# CITY OF ST. HELENS PLANNING DEPARTMENT STAFF REPORT

Variance V.1.21

164 S. 1st Street

Variance to allow a reduced front yard (setback)

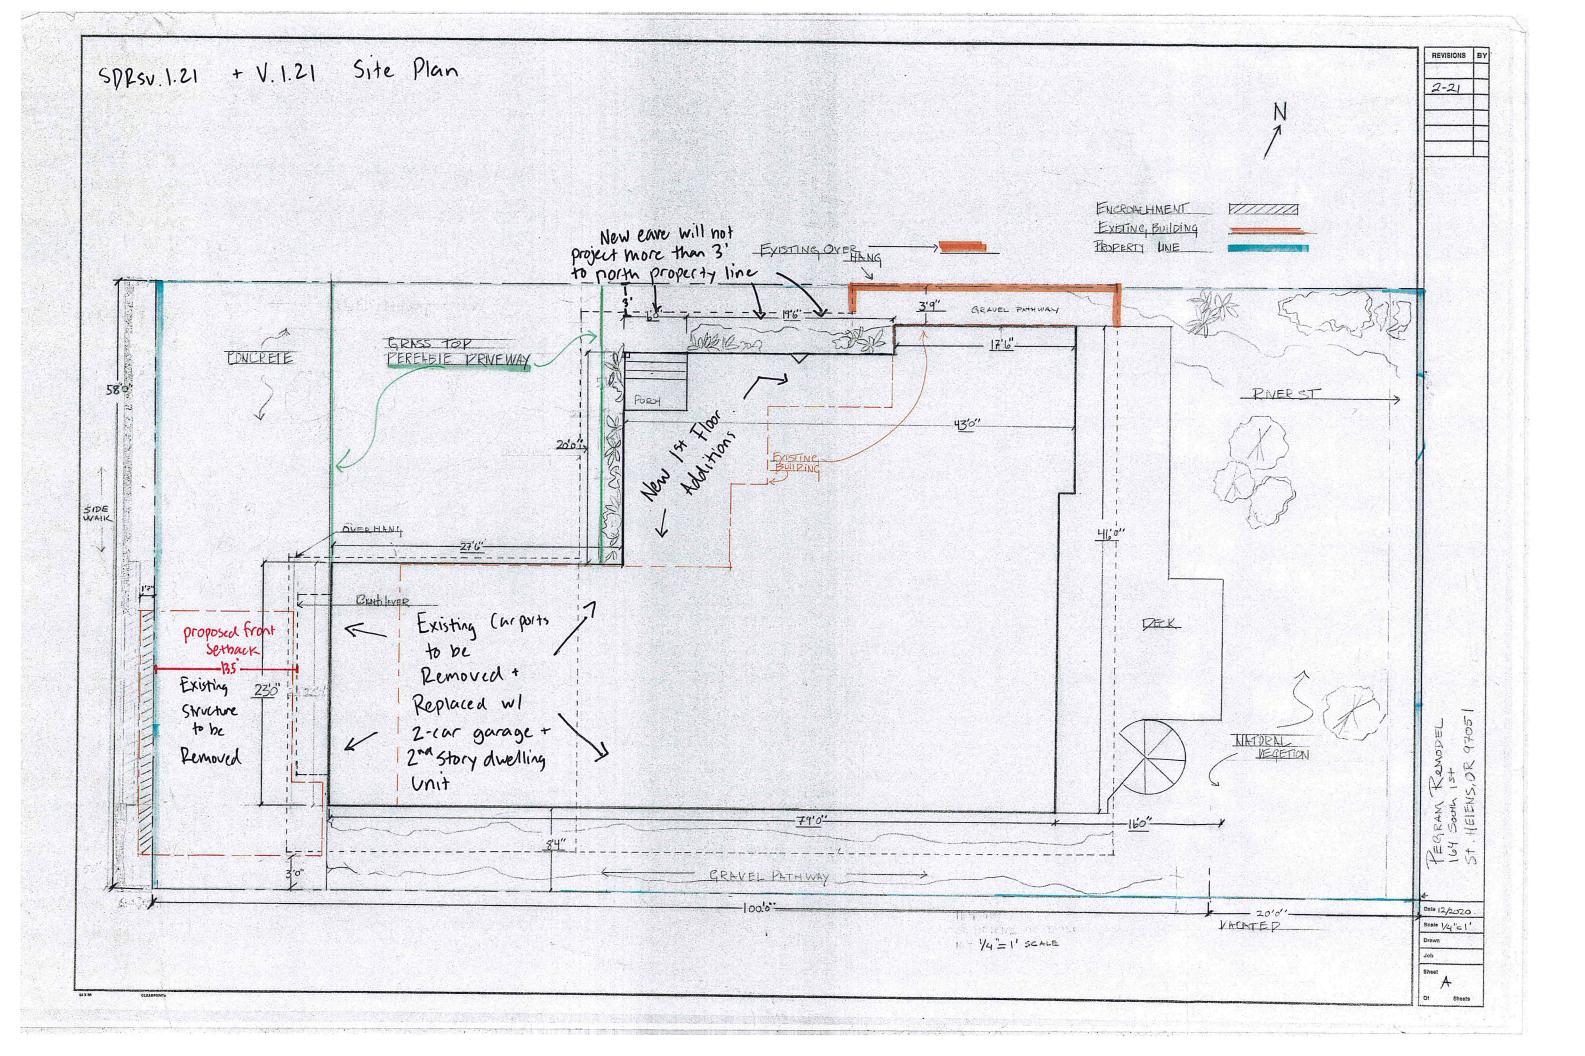
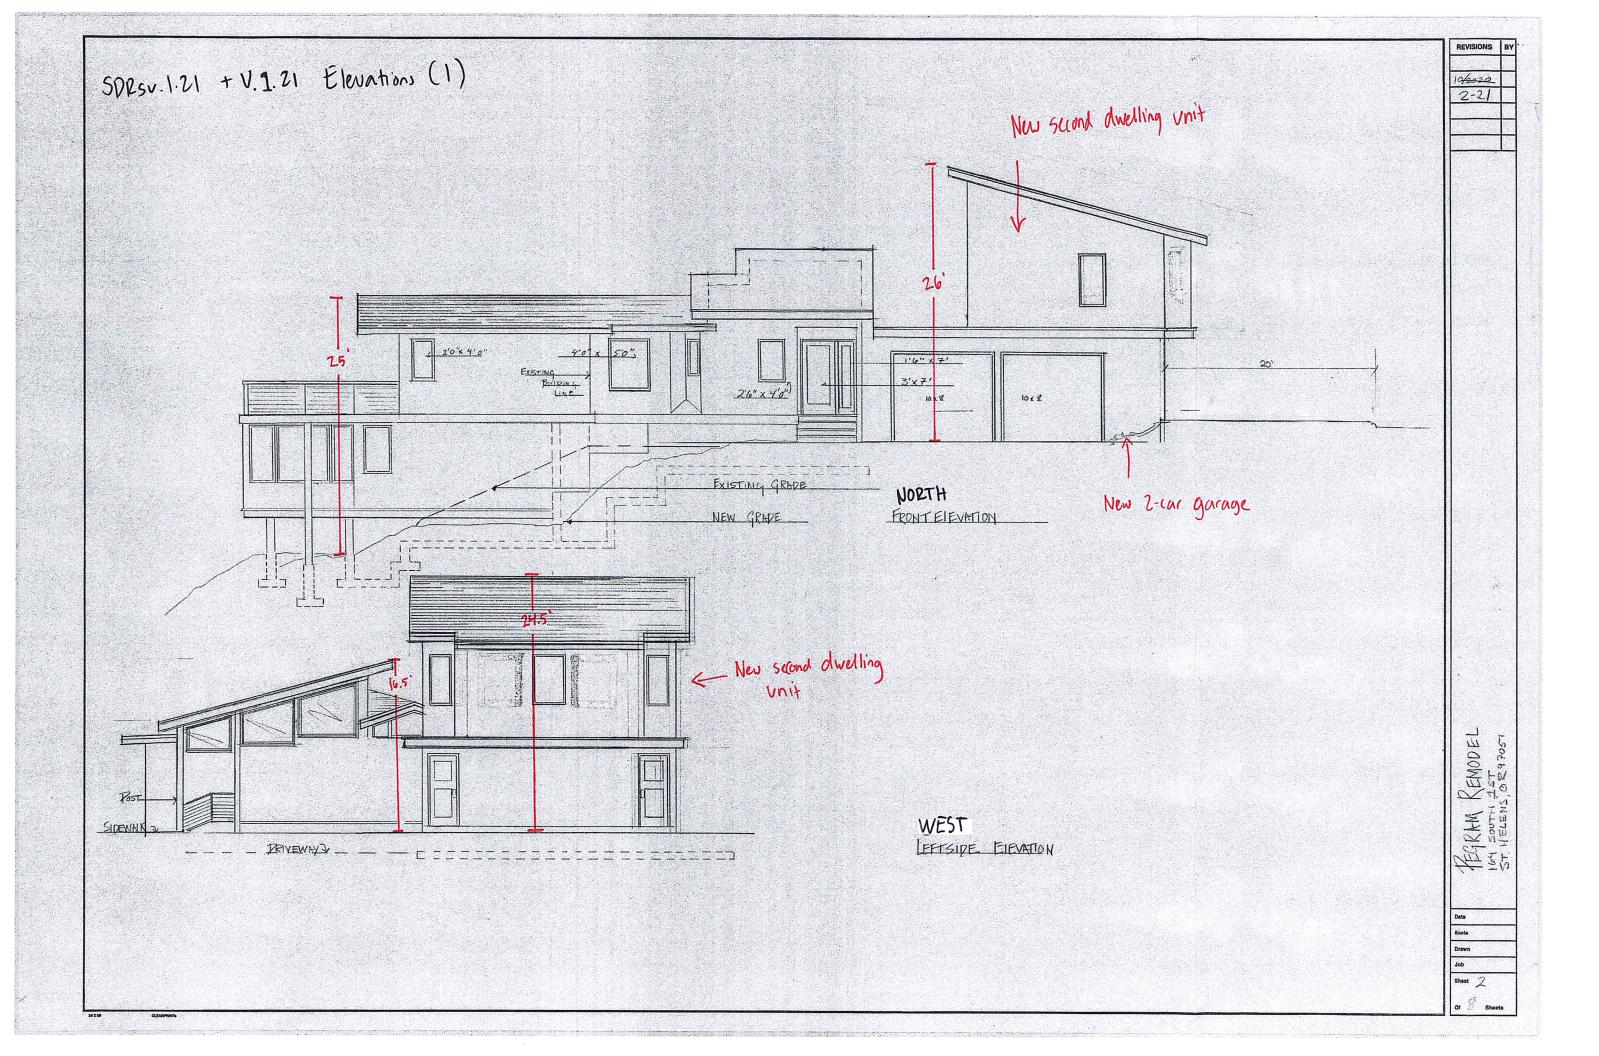
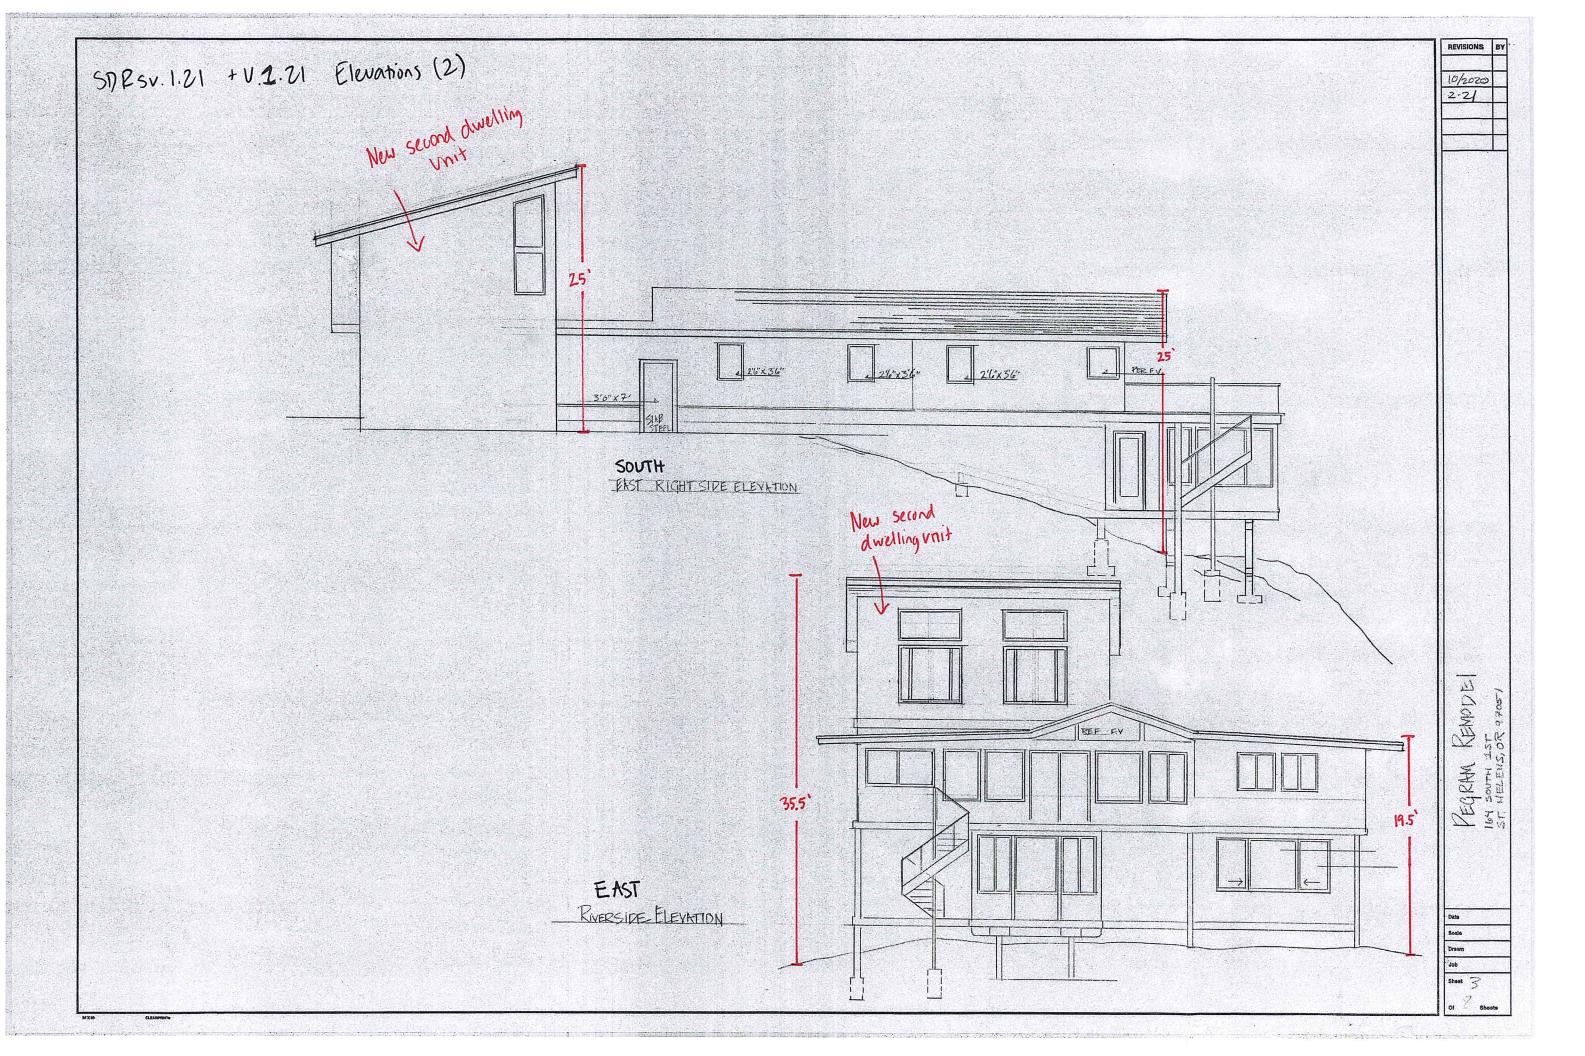
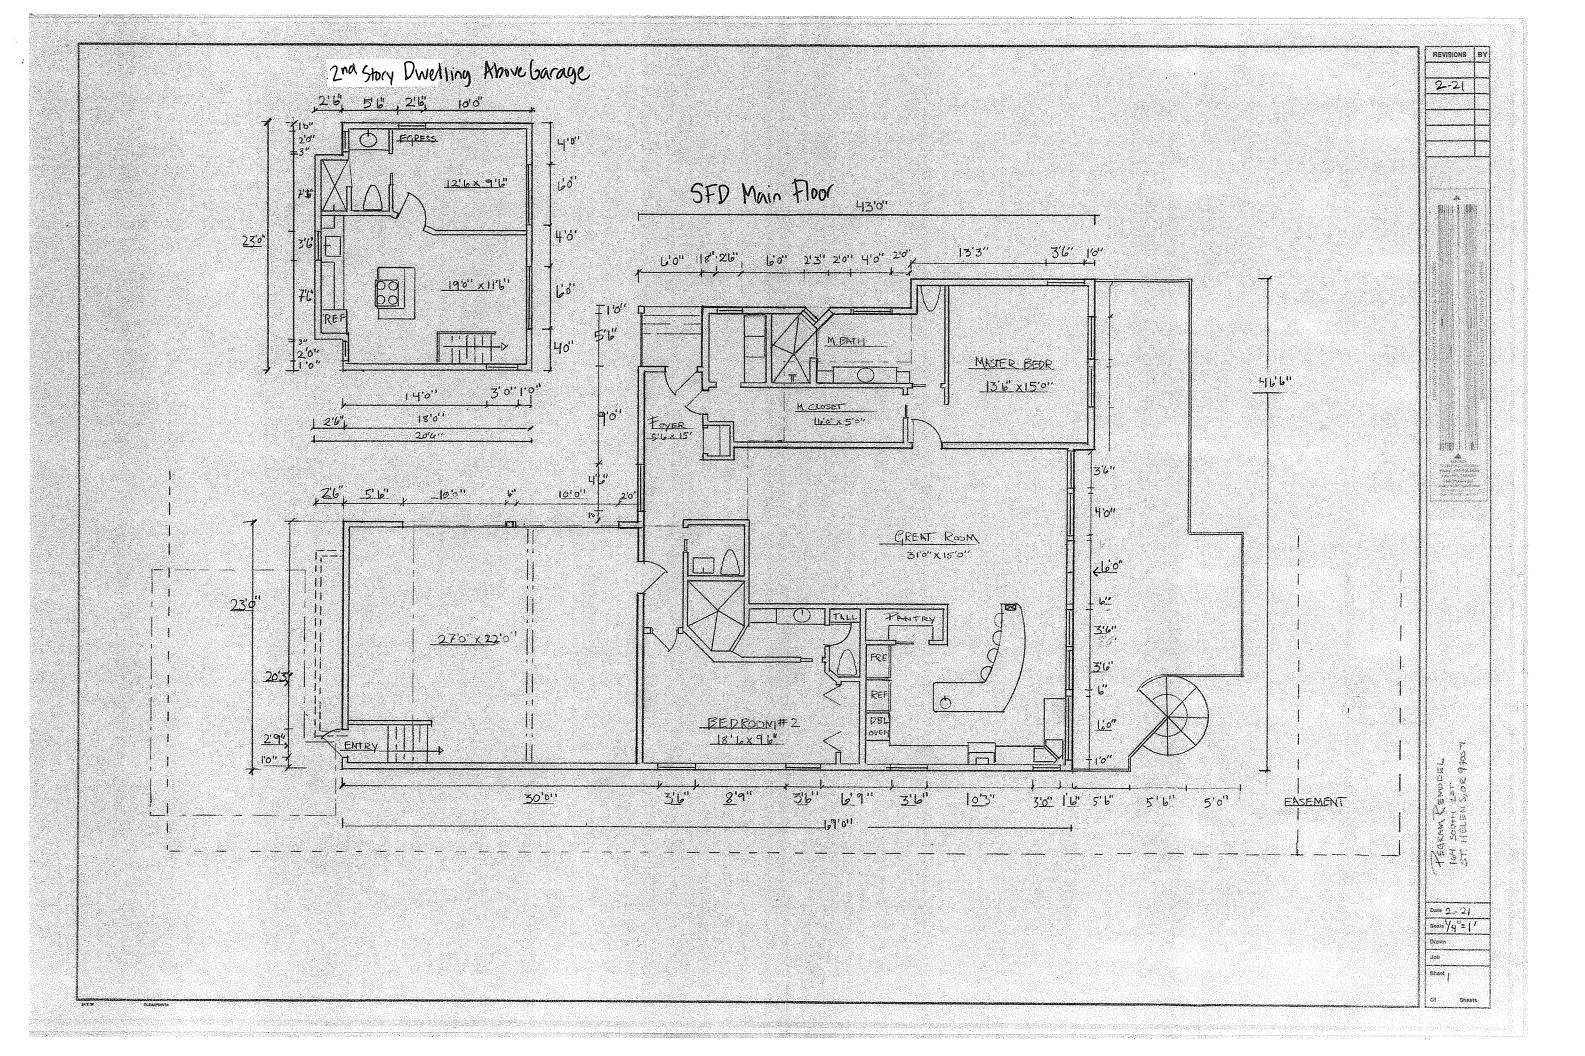
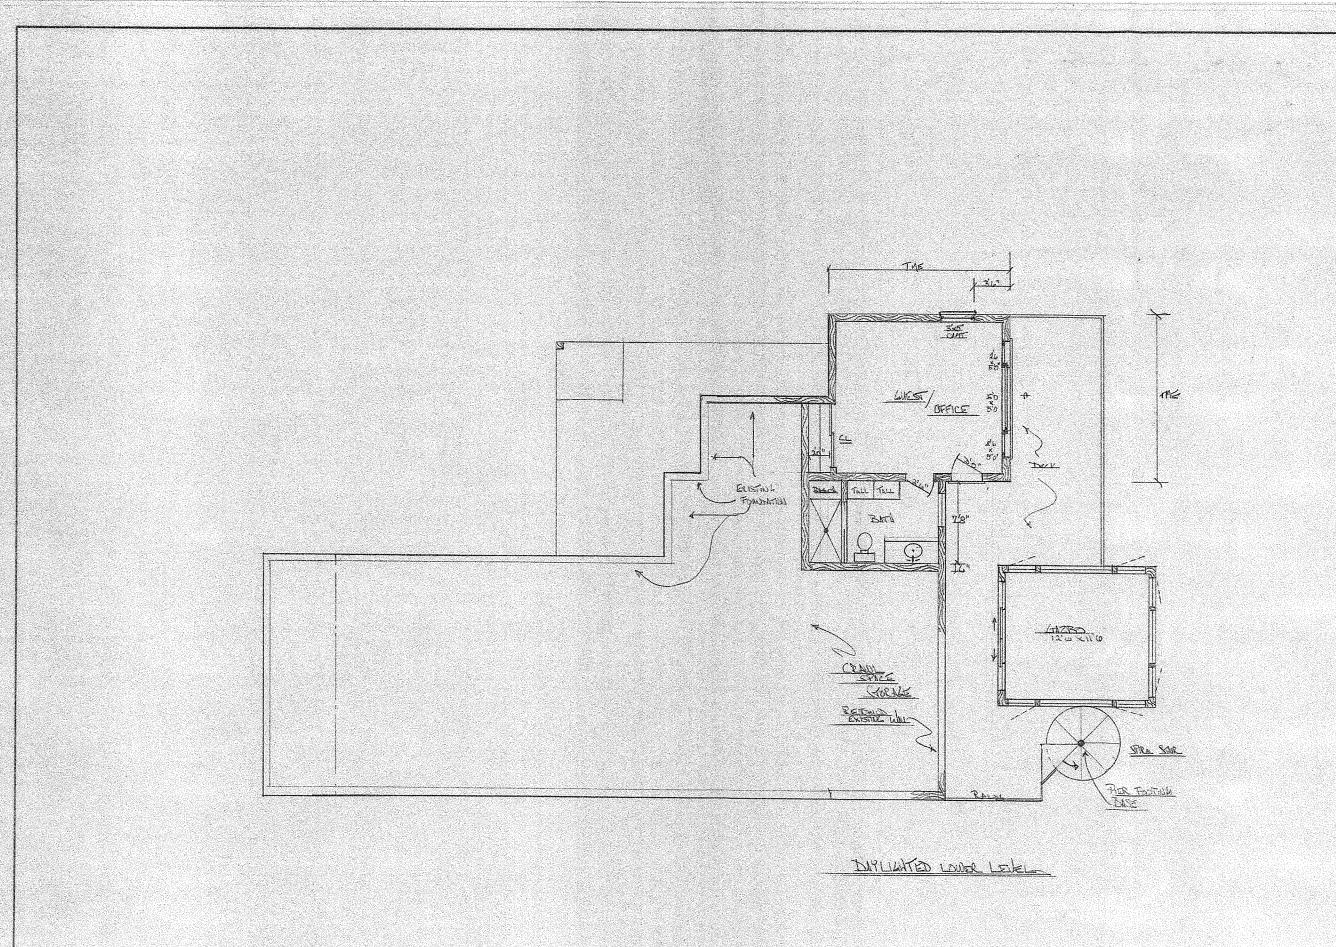
The site plan shows a new eave along the northern property line about 2.5 feet from the property line. The applicant has stated that this eave is intended be at least 3 feet from the property line. If the new eave is less than 3 feet from the property line, a separate variance is required. The

- 1. This Variance approval is valid for a limited time pursuant to SHMC 17.108.040.
- 2. The new eave along the north property line is to be at least 3 feet from the property line, not 2.5 feet as shown on the site plan. An eave less than 3 feet from the property line will require a separate Variance and approval from the Building Department.
- 3. Owner/applicant and their successors are still responsible to comply with the City Development Code (SHMC Title 17), except for the Variance(s) granted herein.
